WH179 January 2023

Appendix A: Schedule of Changes to Drawings

Schedule of changes to drawings - Rev A to Rev C

Anglia Square Rev A - Rev C Supporting Information

Daylight / Sunlight

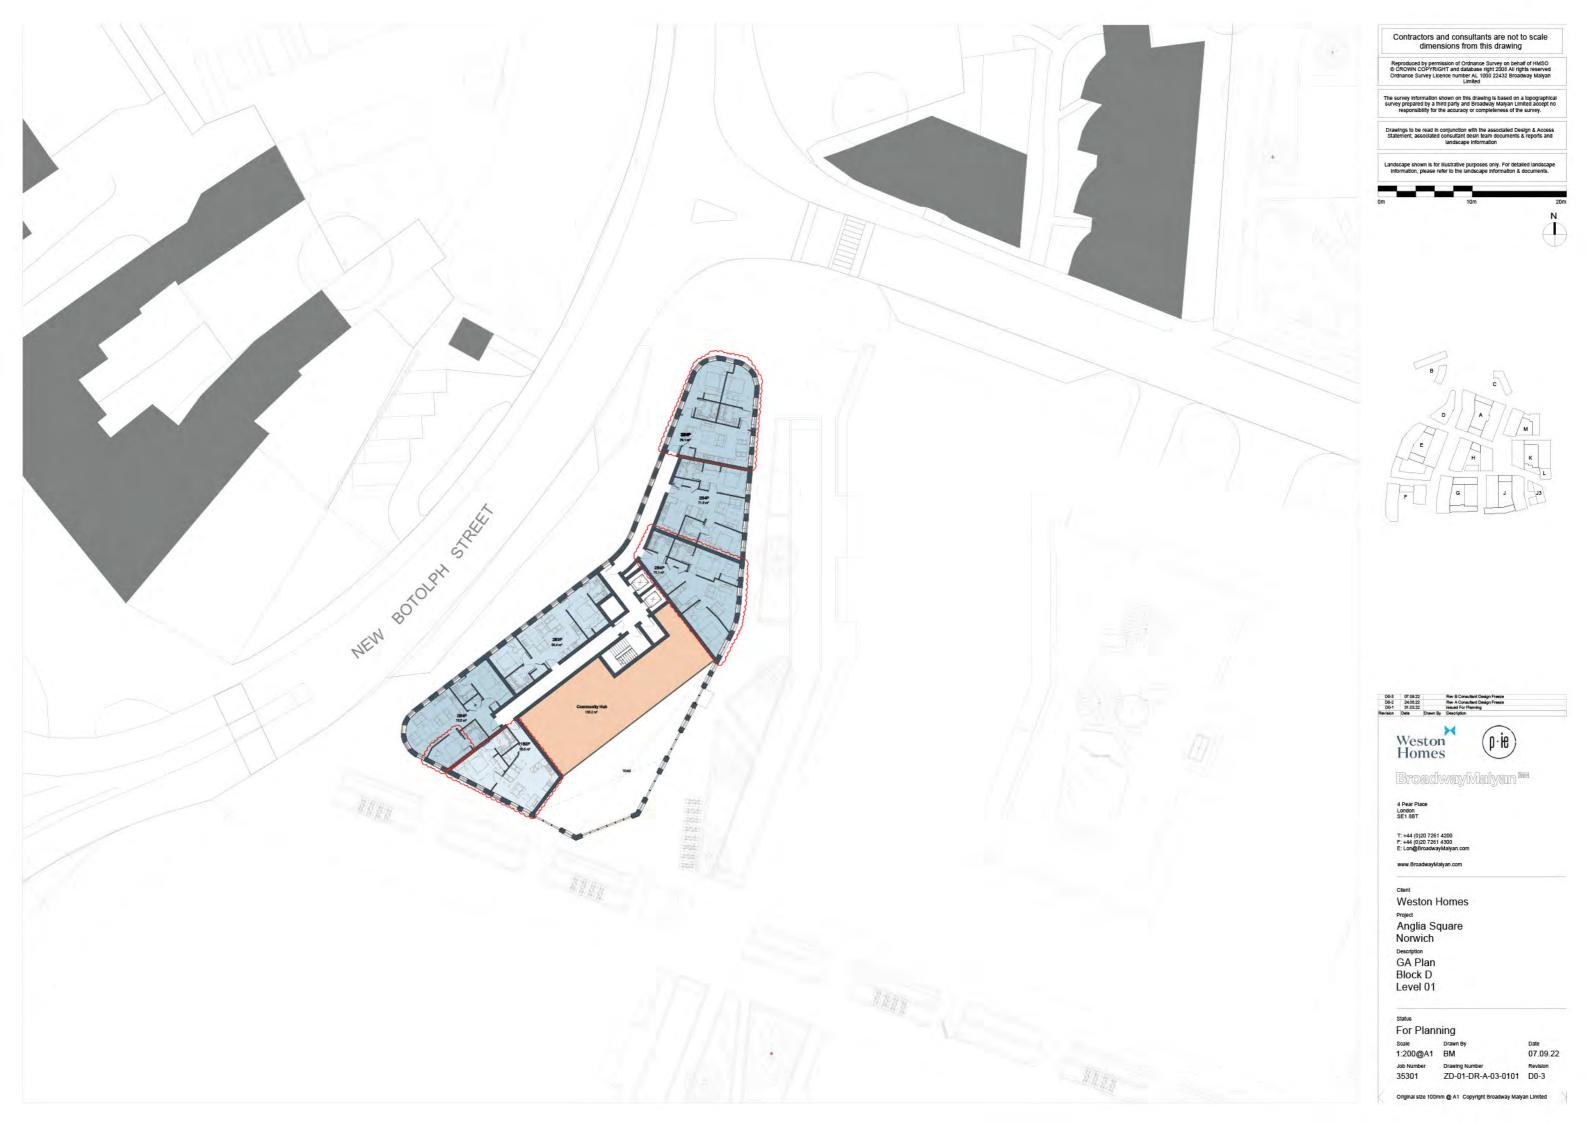
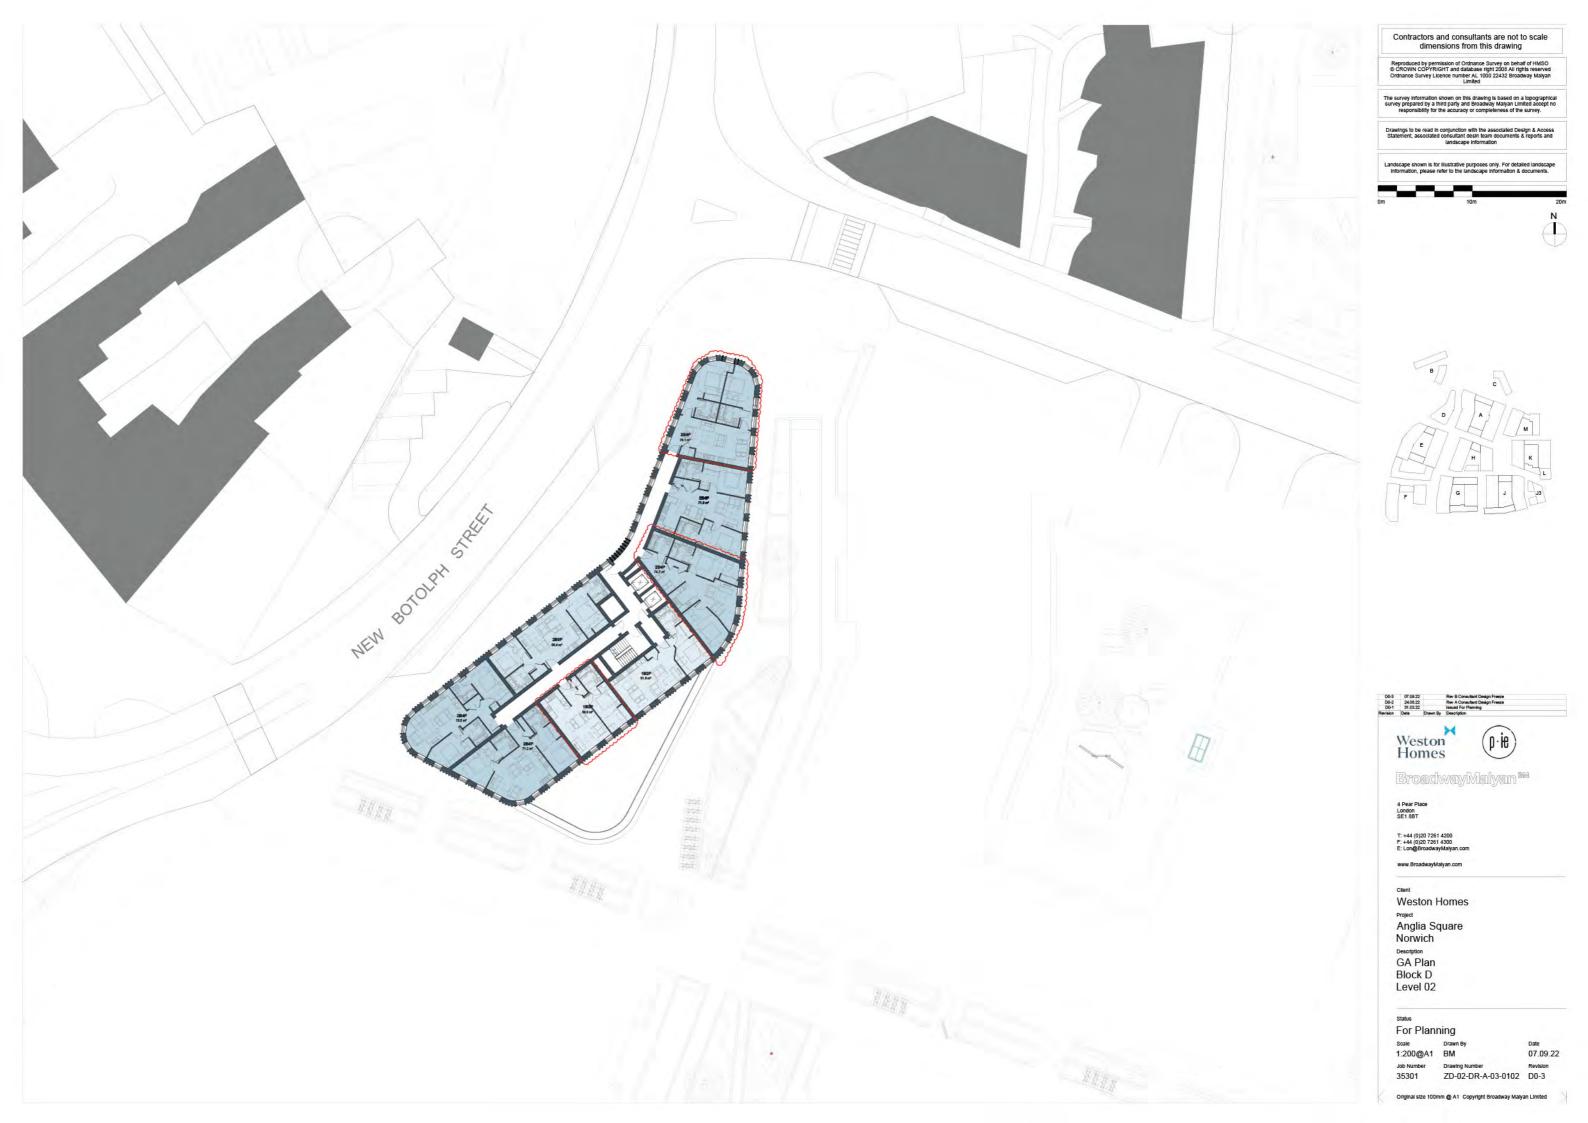
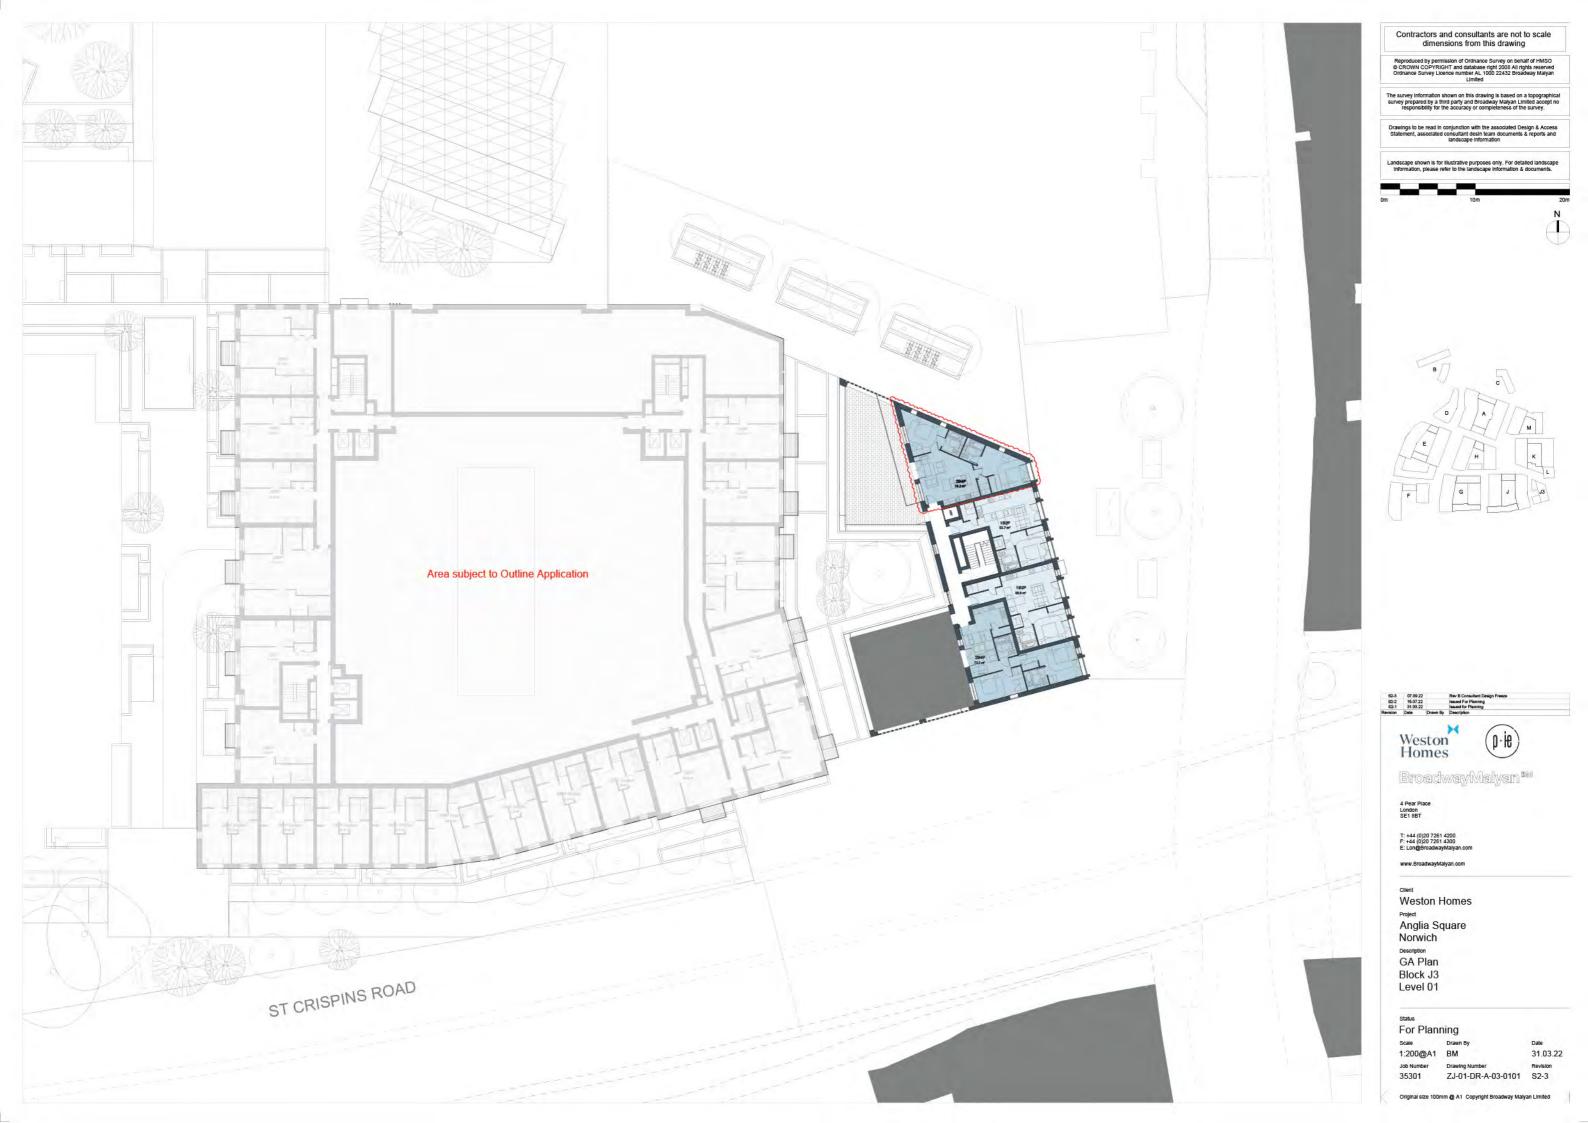
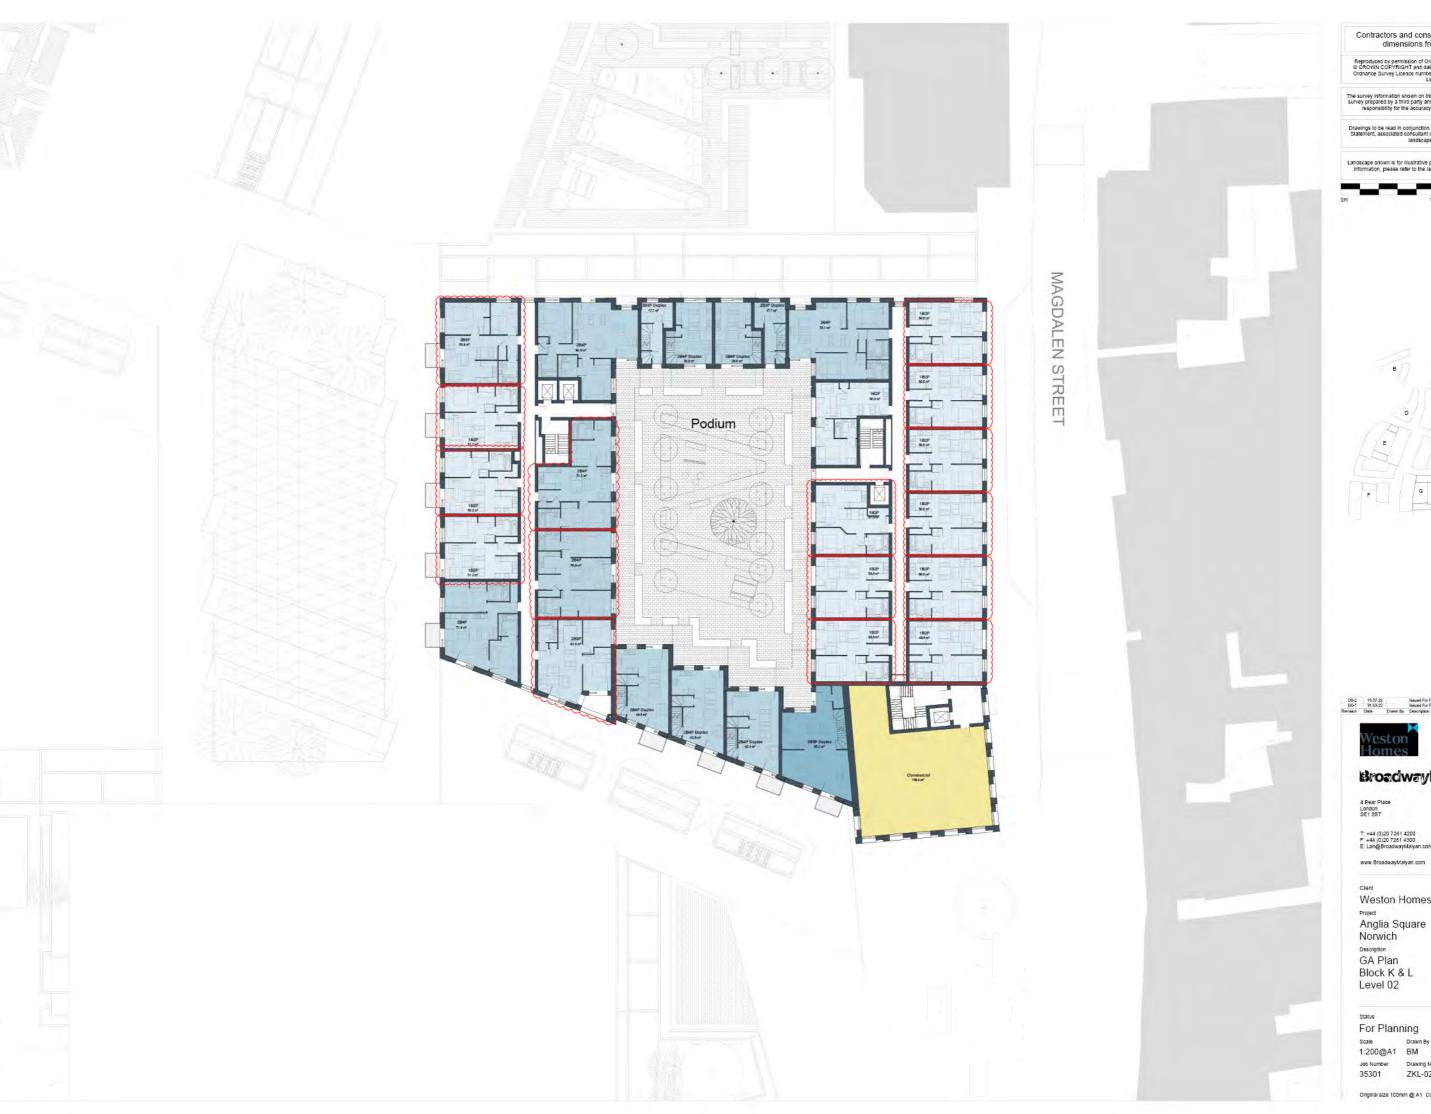
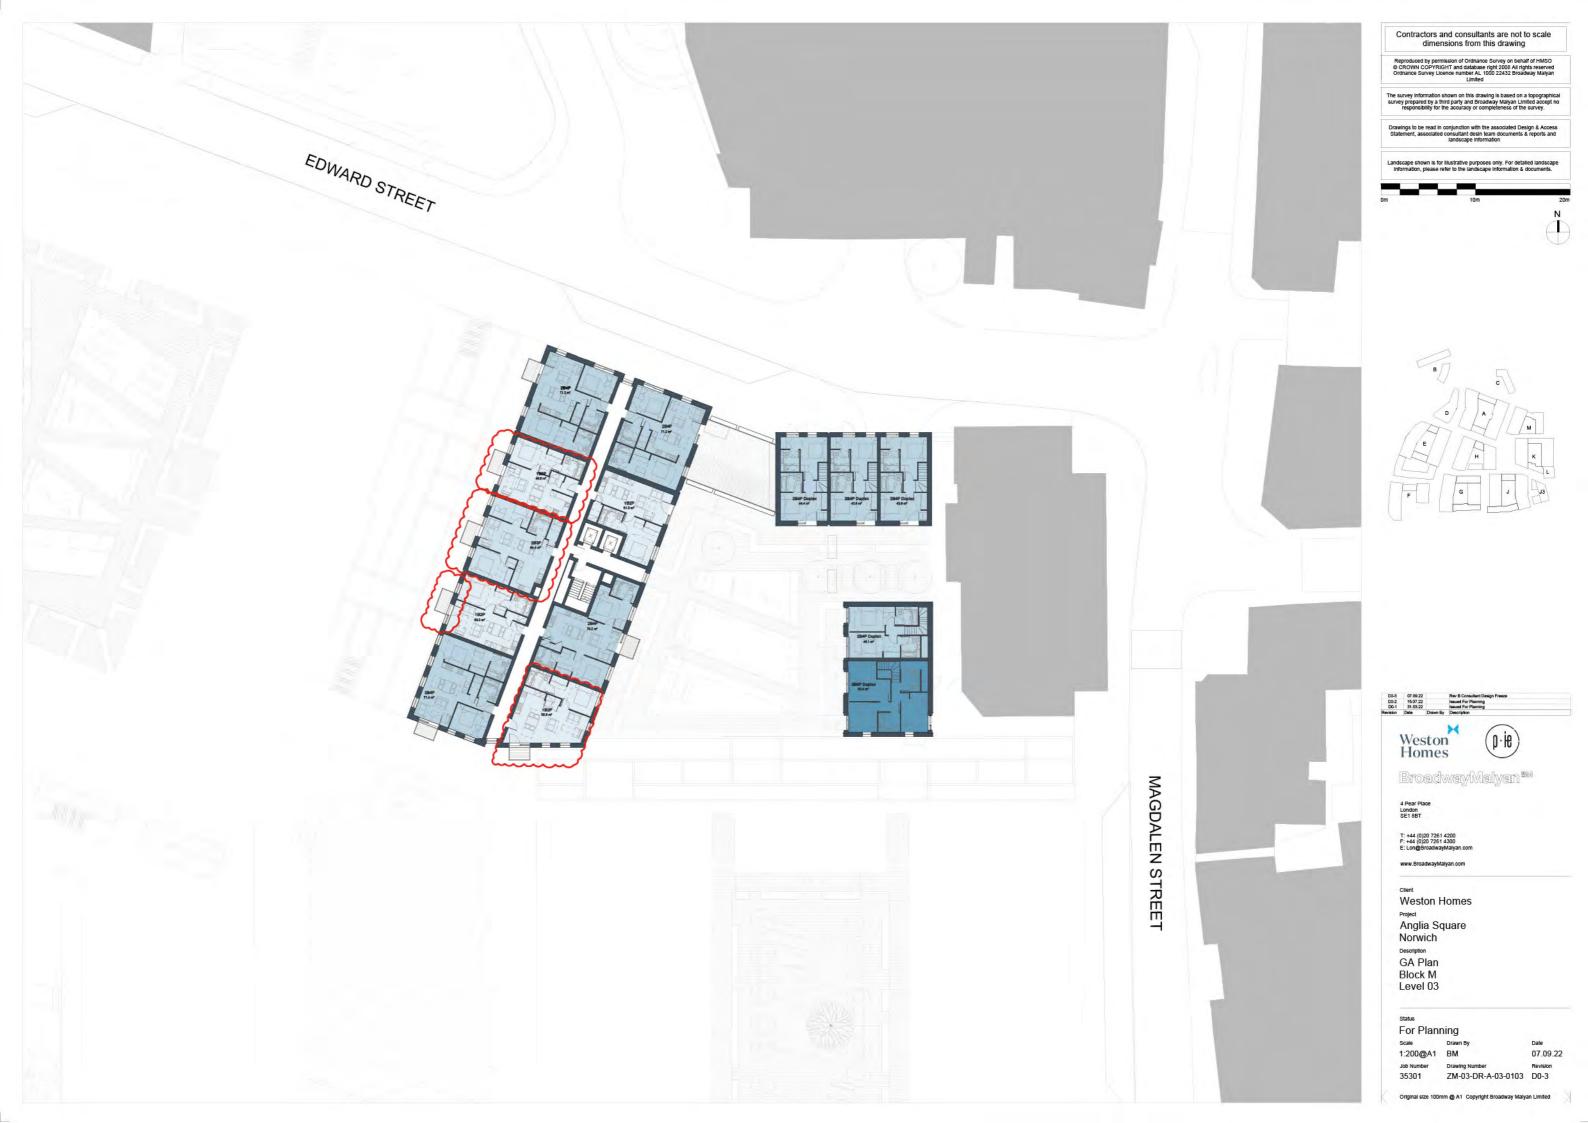
Units reassessed following amendments to internal layouts/ external changes are highlighted in a revision cloud
